Petition No. 1395A
Development and Management Plan Interrogatories

July 6, 2021

Petitioner Responses July 13th, 2021

BENZ STREET SOLAR

SITE PLAN

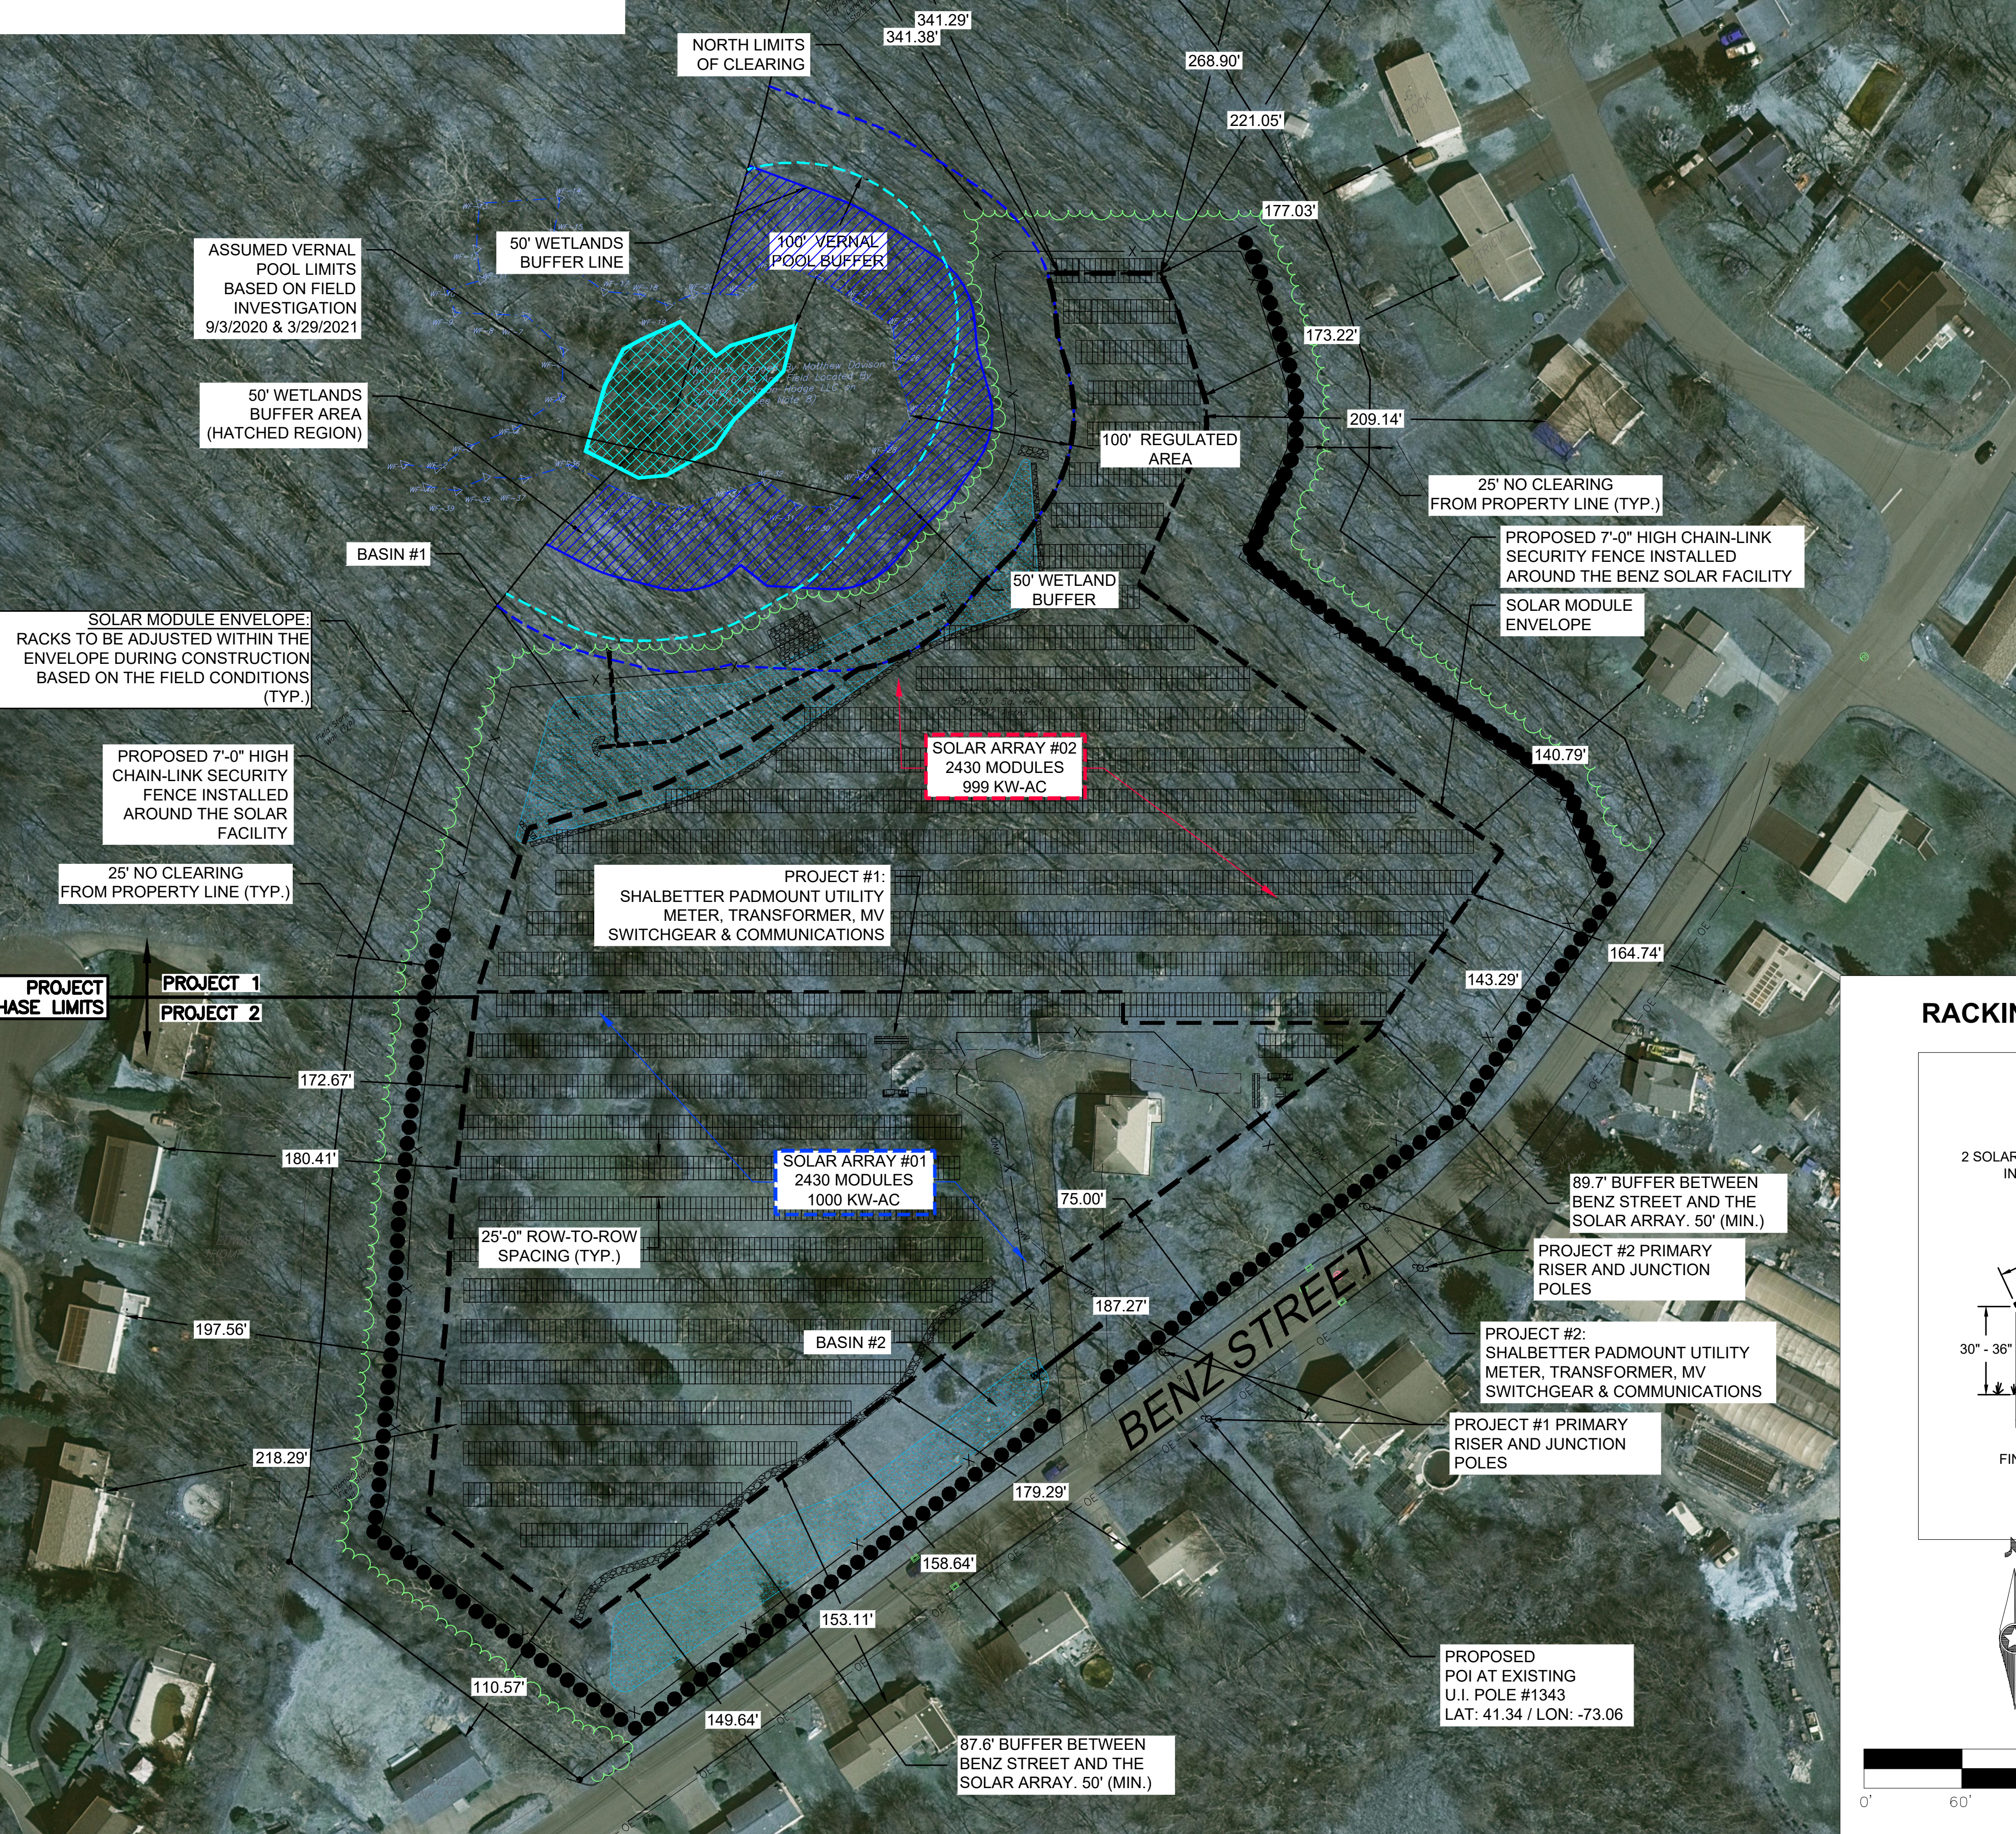
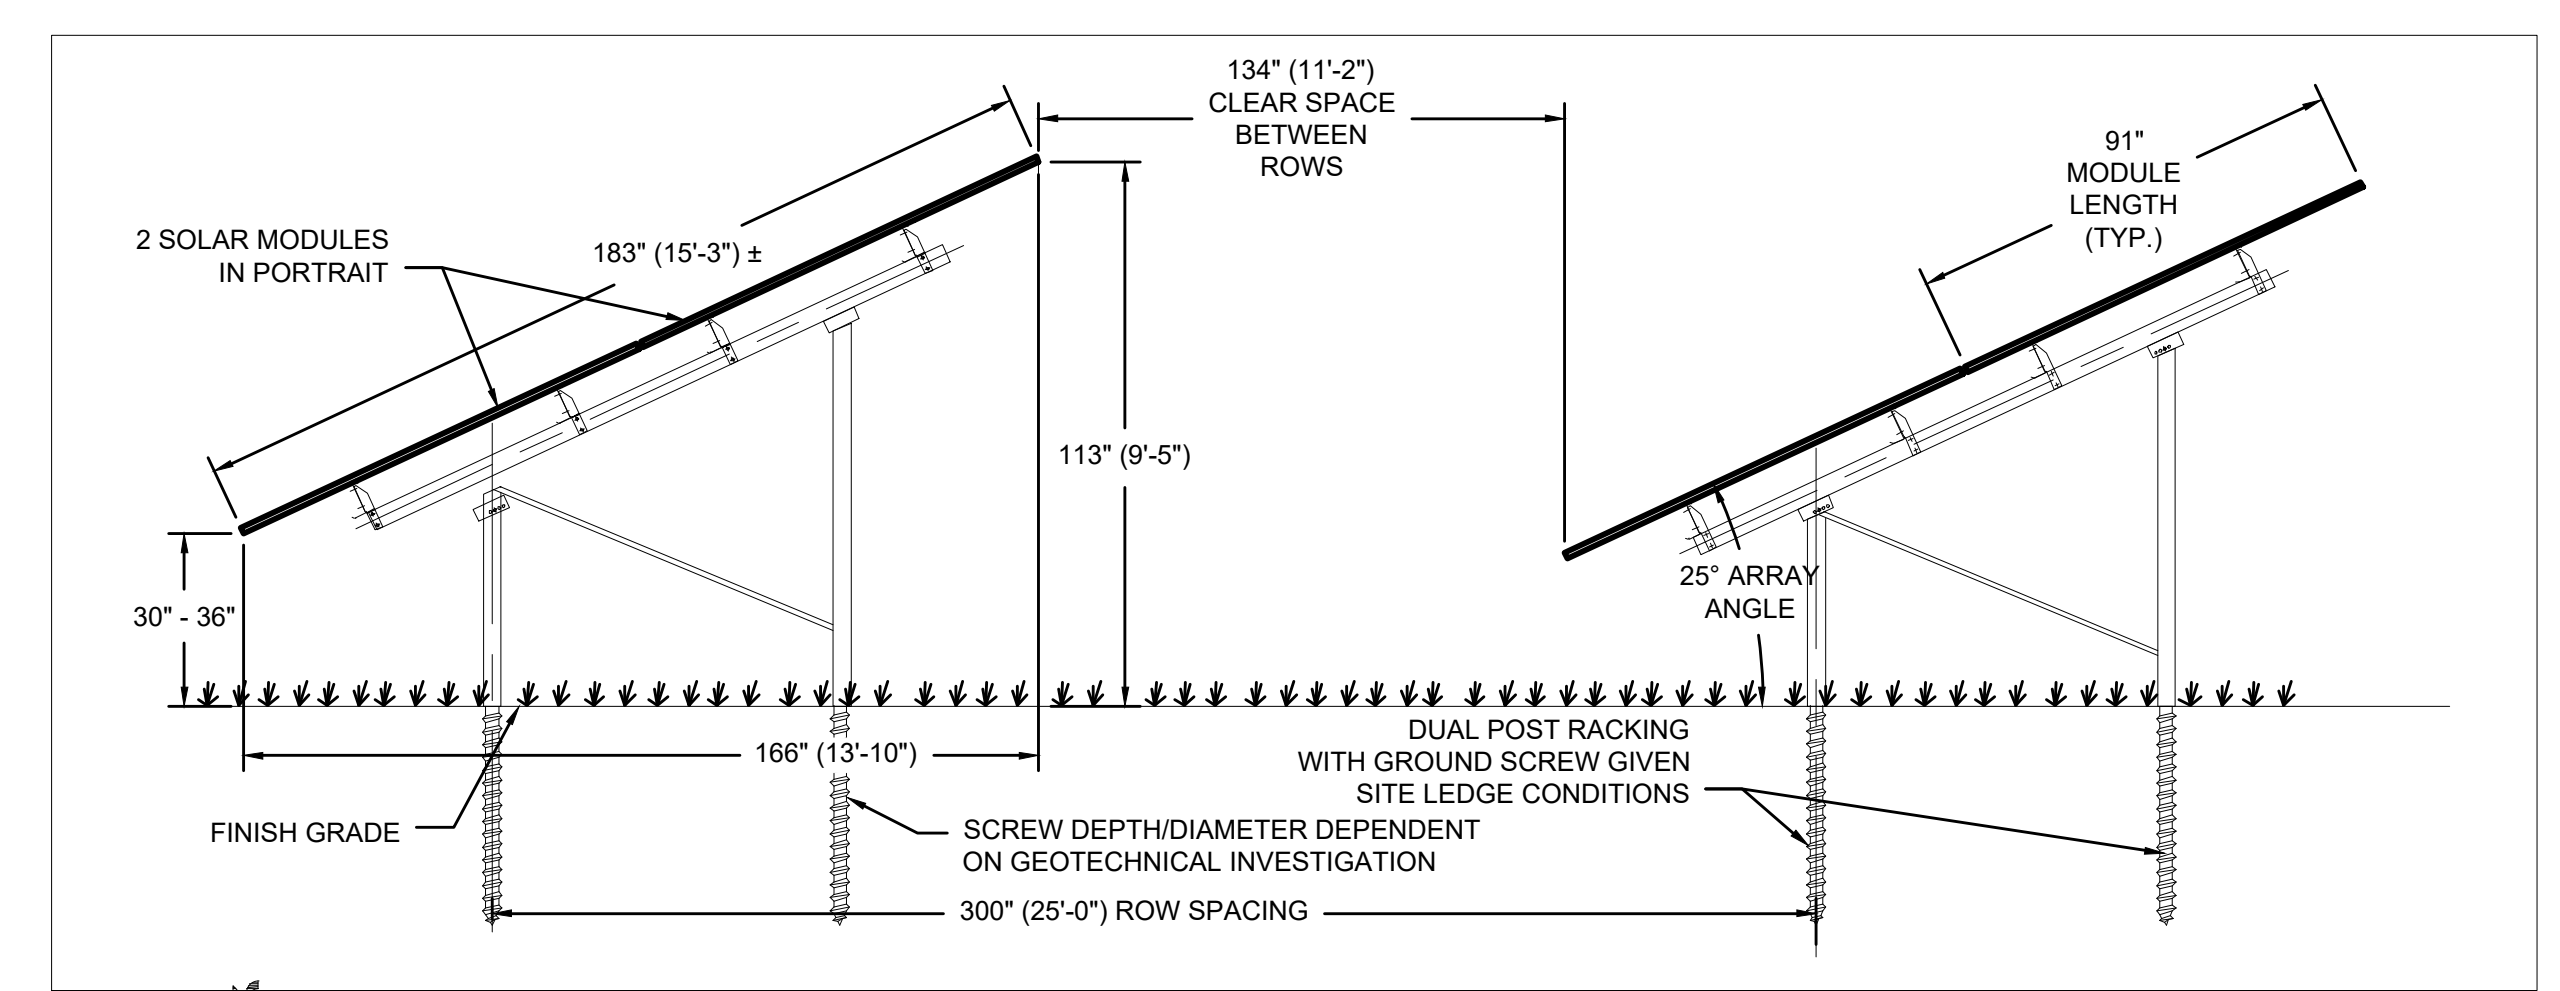
5. Referring to D&M Site Plan Sheet 3 – Project Summary lists 6,136 modules to be installed; however, the callouts on the site plan lists 5,352 modules. Clarify the discrepancy.

RE: The Petitioner is currently planning for 4860 modules based on the Trina 475-watt module. The site plan sheet 3 has been attached as *Exhibit B -Benz Site Plan Sheet 3 rev 10*, with the following project Summary. These values may change by the submission of the electrical portion of the D&M Plan, however modules will still stay within the solar module envelope.

TOTAL MODULE QUANTITY = 4,860 MODULES
